The Sizewell C Project

8.1 Main Development Site Design and Access Statement Addendum

January 2021

Figure 2.8: Indicative view of the Bat Barn

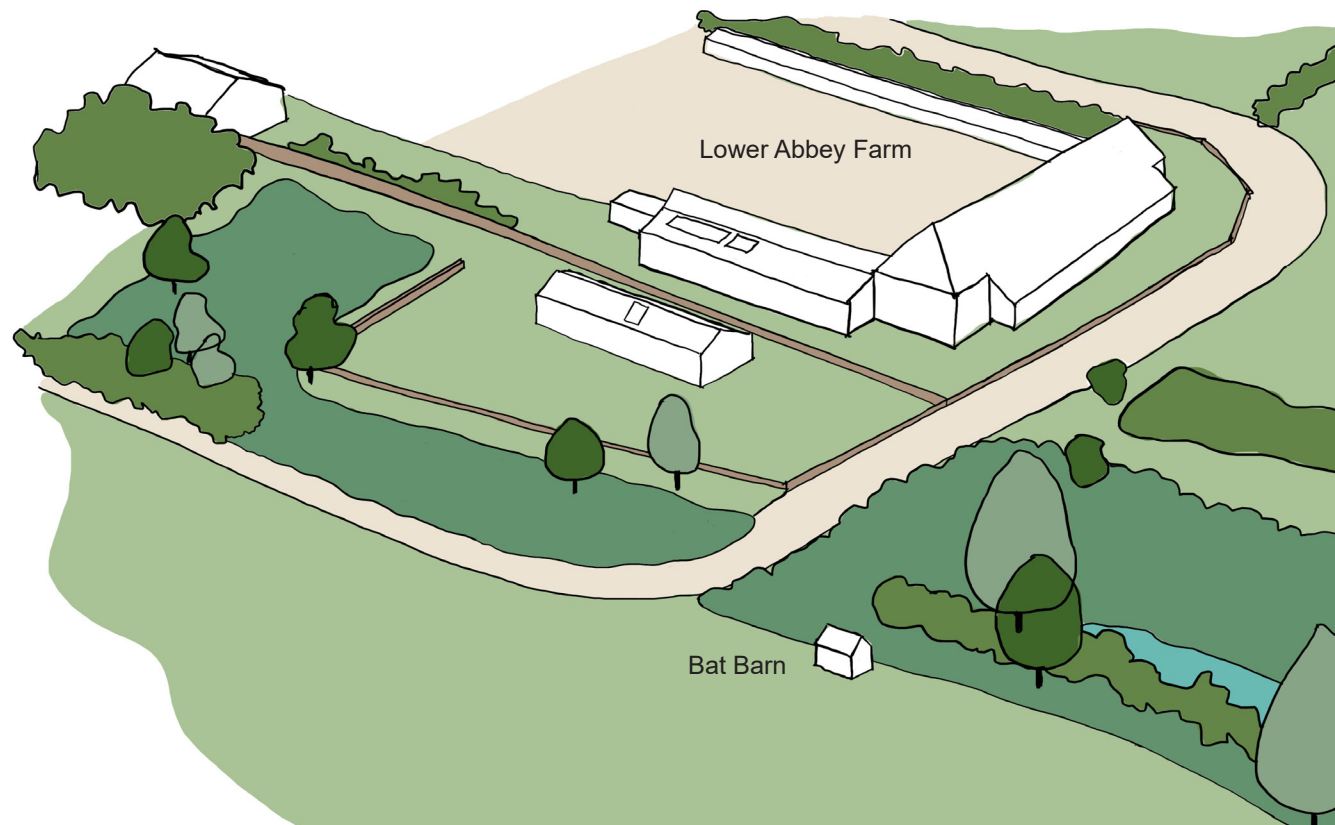
2.6.1 A new bat barn would be constructed to the north of Lower Abbey Farm and form part of the existing collection of buildings to the north of the EDF Energy estate, where it is unlikely to be visible from publicly accessible locations. Grouping the bat barn with the existing farm buildings at Lower Abbey Farm provides an established context of built infrastructure within the landscape. The structure would be a maximum height of 8m AOD and the footprint would be up to 25m². It would comprise a lightweight, piled structure designed to have minimal impact on the environment. An illustrative image showing the location of the bat barn in the context of Lower Abbey Farm is shown at **Figure 2.8**.

Figure 2.9: Visualisation of SSSI crossing

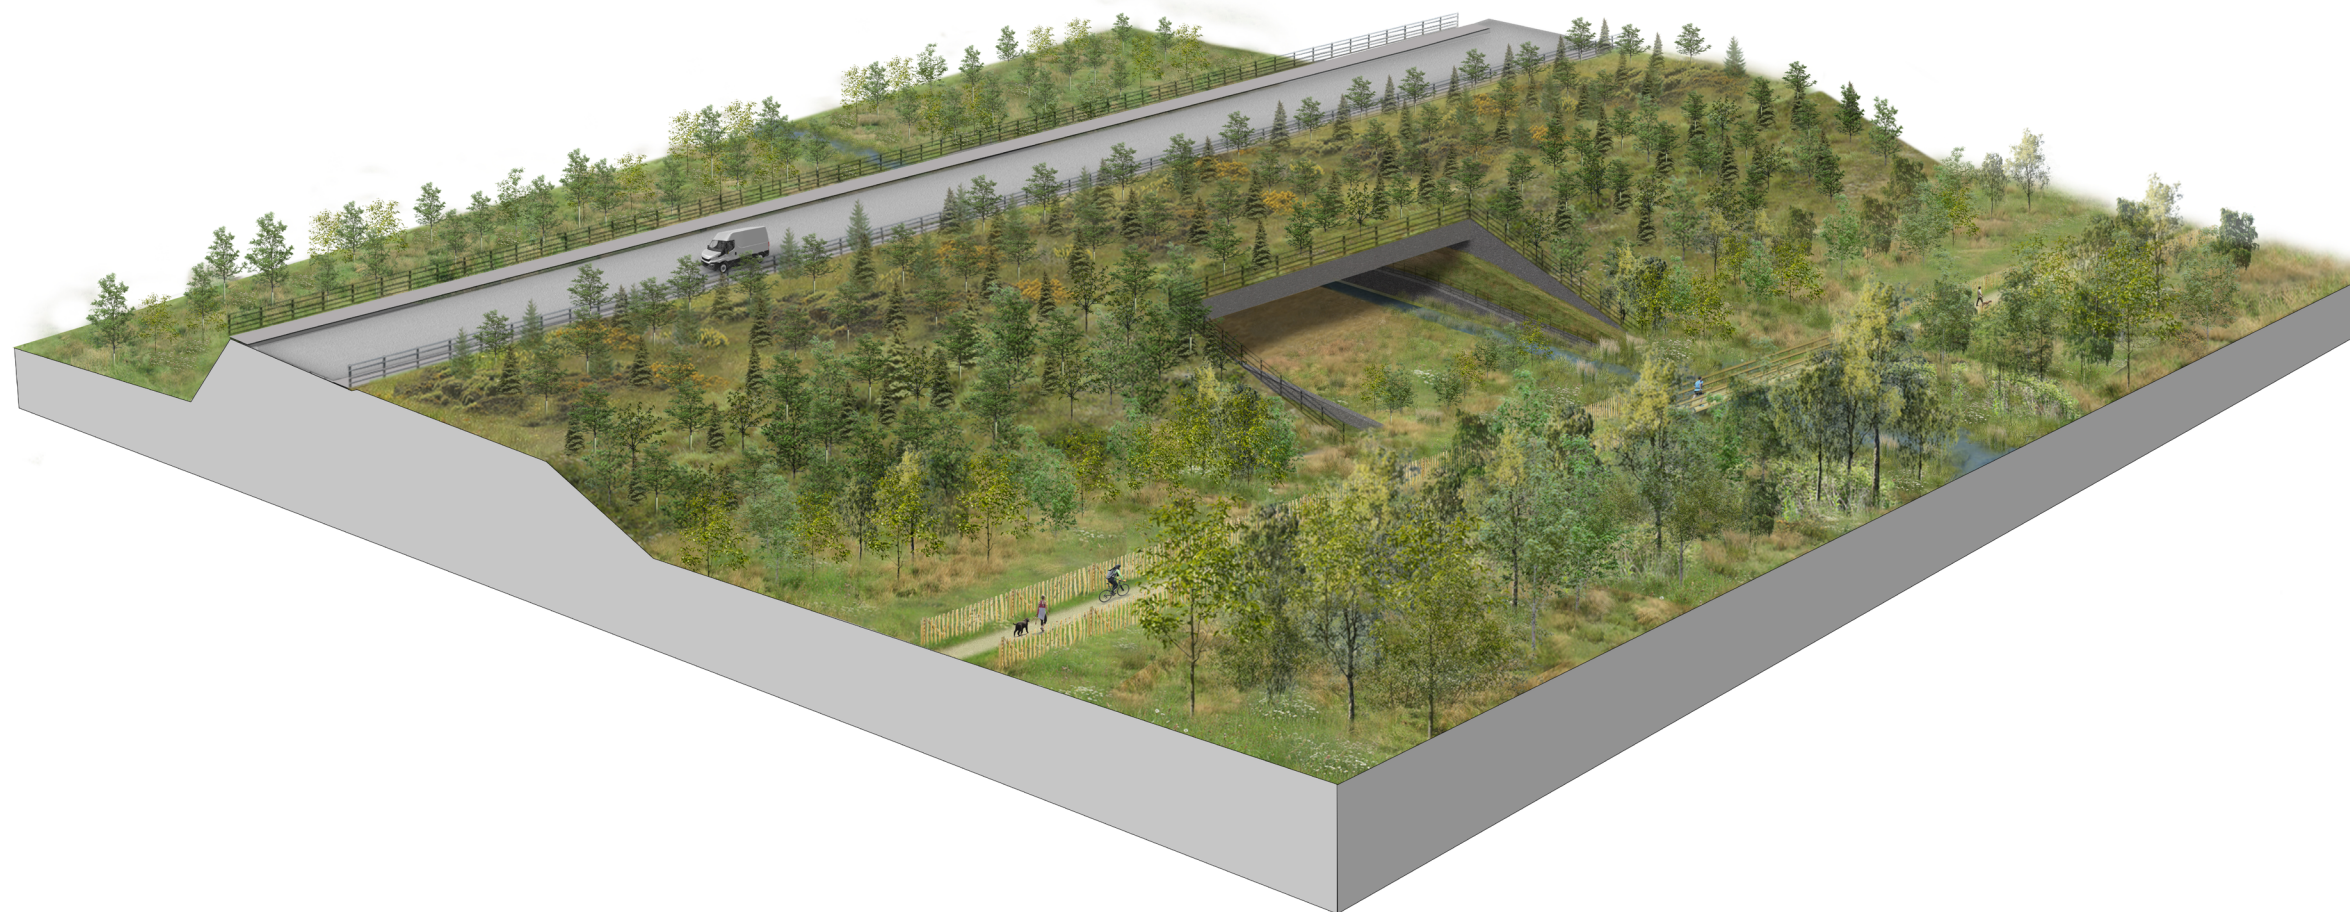
- 2.7.3 The proposed design would comprise separate embankments at either end of the SSSI crossing with a 30m long single-span bridge connecting them and the permanent access road positioned on top. The embankment would have an approximate width of 40m at road level and an overall width of 70m at its base. The footprint would remain the same for both the construction and operational phases of the masterplan to minimise disturbance to the SSSI corridor. The embankment is designed to support any future increase in crest height should there be a need to provide increased flood protection to the power station.

- 2.7.4 Following further design work, the seaward facing slope of the SSSI crossing would be set at a gradient of 1:3 (compared to 1:2 in the Application) to facilitate the establishment of vegetation and present a more naturalistic landform where it is visible from adjacent footpaths and coastal area. This change in embankment slope would allow for more substantial scrub and tree species to soften the appearance of the crossing and provide visual screening and integration with the existing landscape. The western facing slope would have very limited visibility from public areas and would have a gradient of 1:1 to minimise land take within the SSSI. The western facing slope would be seeded with grass to soften the appearance of the crossing and provide integration with the existing landscape.

- 2.7.5 The construction and operational access road to the power station on the SSSI crossing has a fixed alignment. Therefore, the change in gradient of the embankments would result in the footprint of the SSSI crossing moving eastward slightly, as shown at parameter zone 1E of **Volume 2, Figure 2.2.8 of the ES Addendum**. The alignment of Sandlings Walk would also need to move slightly further east accordingly and is offset from the base of the embankment to the south of the Leiston Drain to allow for screen planting. North of the Leiston Drain the footpath is aligned to the base of the SSSI crossing to minimise the loss of existing trees in this area.

- 2.7.6 A single span bridge would connect the crossing embankments above the Leiston Drain creating an approximate 24m wide passageway which runs perpendicular to the crossing. The passageway is significantly larger than is required for operational purposes and the bank and channel of the Leiston Drain would remain intact. The passageway is of sufficient size to facilitate the passage of bats and water voles through the structure and retain its function as an ecological corridor. A ledge would still be installed to enable passage by otters and artificial bat roosts would be included within or on the bridge abutments.

- 2.7.7 The construction haul road would be removed at the end of the main construction phase and then planted with trees as part of the operational phase to provide screening of the site access road. The retained access road would be positioned to the western edge of the embankment, away from the coastal edge and would not be lit to reduce environmental impact. The carriageway would have an approximate width of 12m width and require 3m high safety barriers on either side. A visualisation of the SSSI crossing is shown in **Figure 2.9**.

Figure 2.10: Visualisation of the sea defence

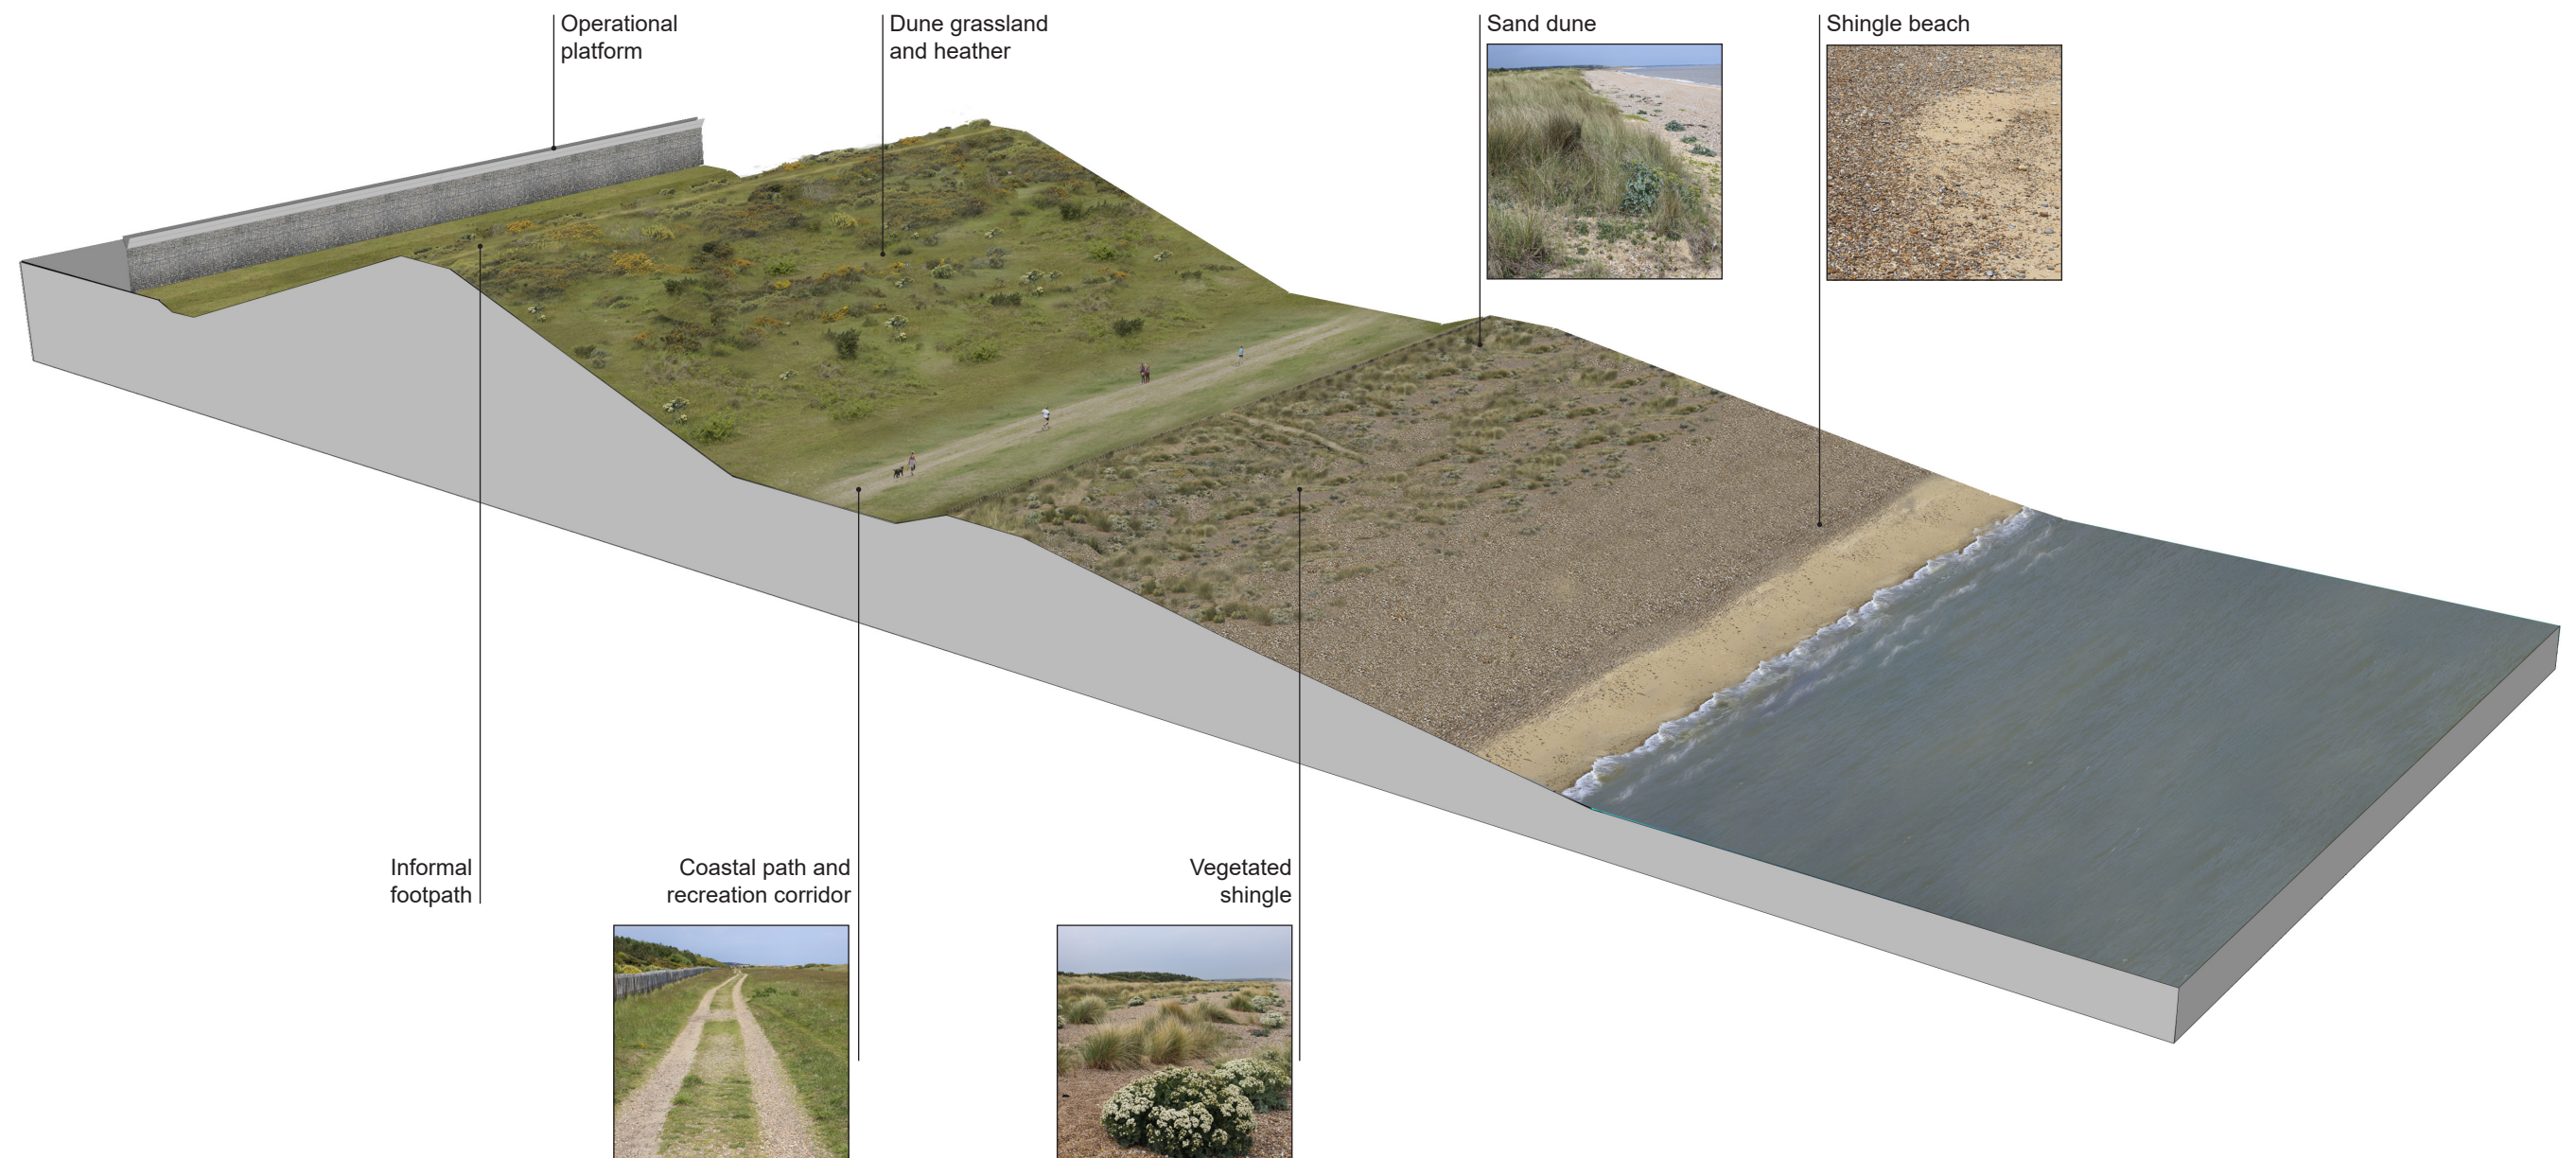
- 2.8.1 The permanent sea defences (including the northern mound) would protect the main platform from flooding during storm surges and high waves.
- 2.8.2 The proposed design includes a change to the minimum crest height of the permanent sea defence (including the Northern Mound) from +10.2m AOD (excluding landscaping) to +12.6m AOD (excluding soil build up to support vegetation /planting). This height provides for a 1 in 10,000 year storm event at 2140, including a precautionary assumption for wave height. The seaward toe of the sea defence would be buried to a depth of no less than approximately +0mOD.

- 2.8.4 The permanent design of the Northern Mound would include rock armour placed on the seaward side of the sea defence, which would be top dressed with substrate to allow for vegetation establishment and to soften the appearance of the mound. The replacement mound would be built up to a height of 14.6m AOD, 2m higher than the height required to meet flood protection requirements and 2.6m higher than the existing Northern Mound. Raising the height of the mound to 14.6m AOD has significant advantages in screening lower level structures on the main platform from sensitive views along the coast.

- 2.8.7 The crest of the sea defence would vary between 13.2m – 14.6m AOD, including a 12.6m AOD hard engineered structure to meet the necessary flood protection requirement, and an additional 0.6m – 2m of substrate to allow for vegetation establishment and to naturalise the appearance of the bund. The substrate layer would be constructed to varying depths in order to create undulations in the landform, to naturalise its appearance and create niches for habitat variation.

- 2.8.8 The seaward facing slope of the defence would be set at a typical gradient of 1:3 to encourage the establishment of vegetation and deliver a more naturalistic landform where it is visually prominent from the coastal area. The face of the bund would undulate and be planted with coastal scrub and dune grassland species. It would be managed in line with the existing Sizewell B sea defence to achieve a similar naturalistic appearance. Raising the height of the sea defence by up to +2m above the required flood protection would be achieved through localised steepening of the substrate layer in some sections. This would provide additional screening of lower level structures and activity within and around the power station platform where required.

- 2.8.10 An approximate 12m wide plateau would be created along the seaward face of the defence at a minimum height of 5.2m AOD, to accommodate the England Coast Path and the movement of security patrol vehicles along the coast. The design of the sea defence allows for variation in the width and height of the plateau to create a naturalistic landform. Further east and towards the sea, the soft coastal defence would be raised along the existing line of the soft sea defence to provide additional coastal protection with the existing vegetated shingle and beach habitats replicated. A visualisation of the sea defence is shown on **Figure 2.10**.

Figure 2.11: Visualisation of the beach landing facility and access road

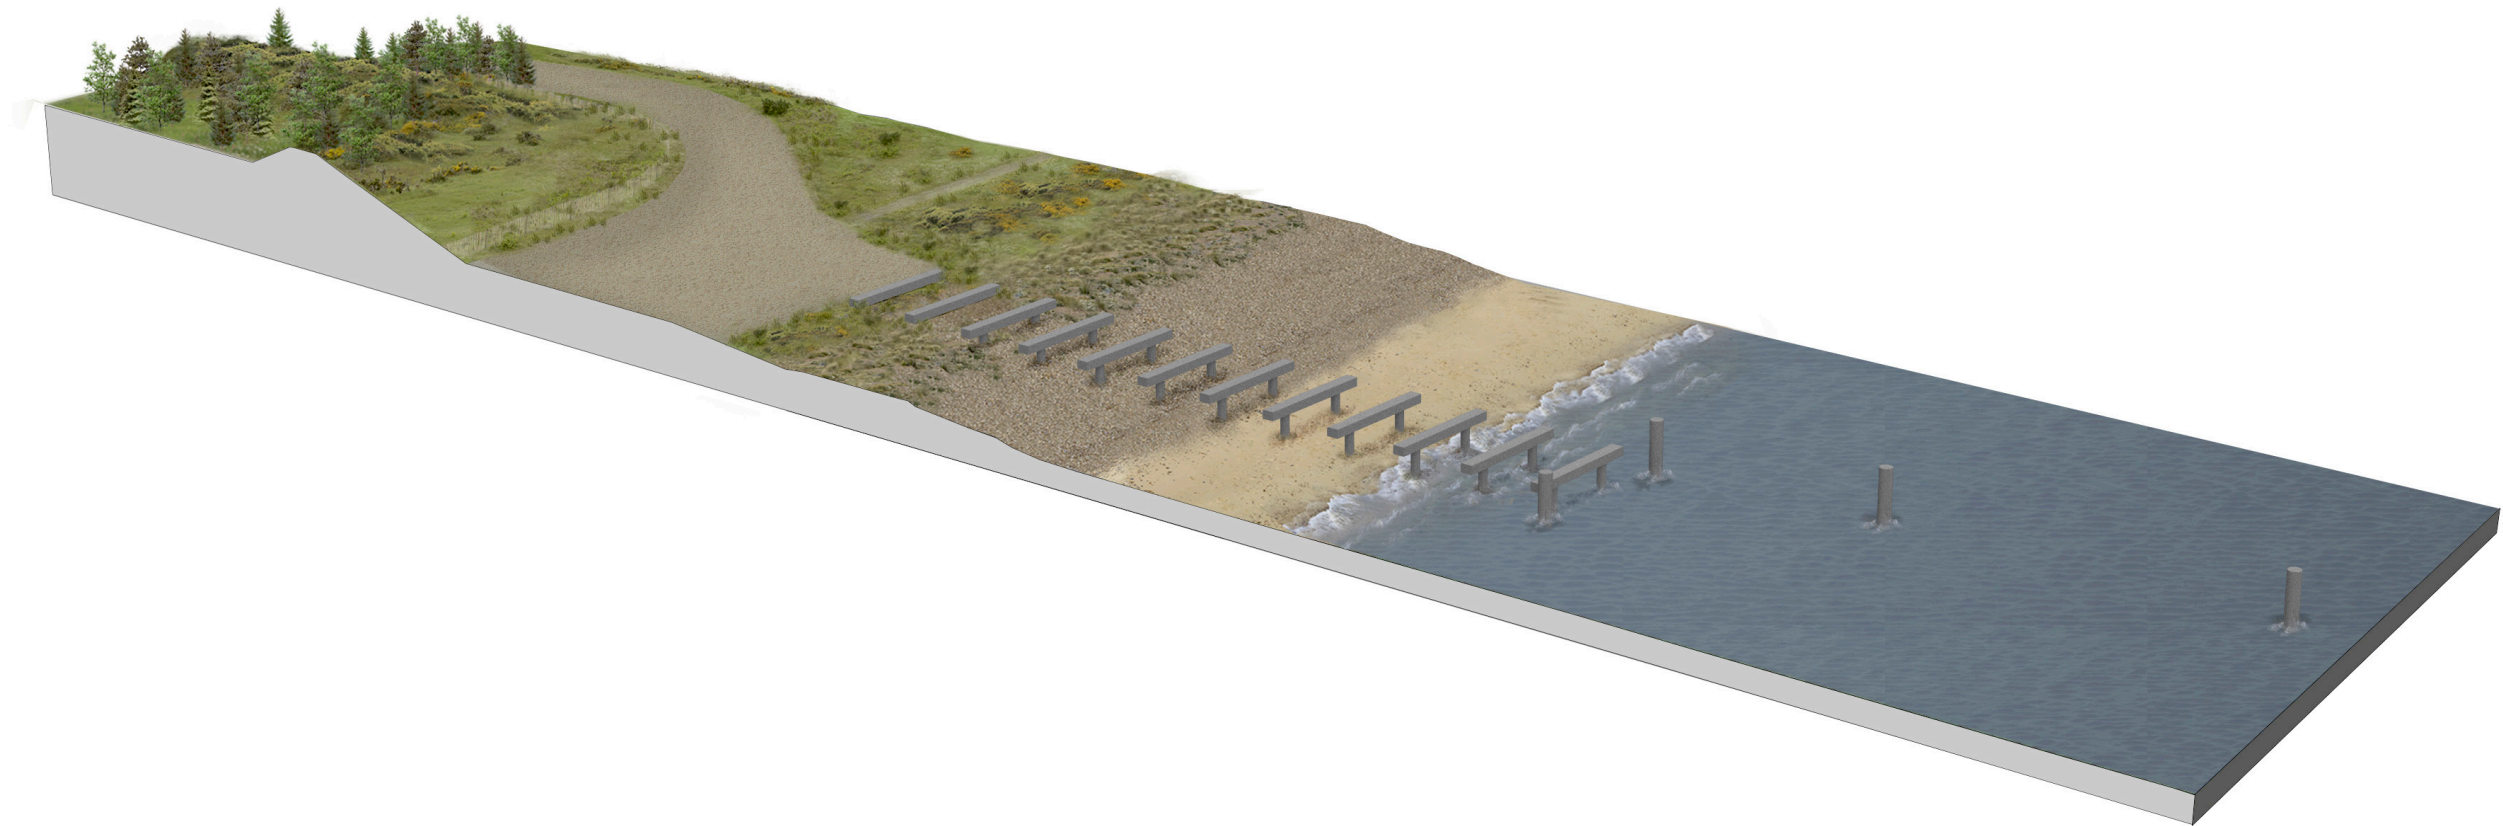
2.9.2 The enhanced design of the permanent BLF would substantially increase the ability of the BLF to receive AILs more regularly during construction. The proposed change would add a submerged grounding platform at the seabed (also known as grillage) and extend the length of the BLF by approximately 30m (100m in total) to better align the barge deck with the platform, making deliveries safer and more efficient. Extending the BLF would require an increased number of piles that would form a permanent presence on the coast. The submerged platform would be removed by the end of the Sizewell C construction period and would not be required for operation when the BLF would be used less frequently.

2.9.4 The BLF access road provides a permanent ramped connection between the power station platform (+7.3m AOD) and the BLF landing platform (+5.2m AOD). The access road and landing platform would be constructed from reinforced concrete. A visualisation of the BLF and access road is shown in **Figure 2.11**.
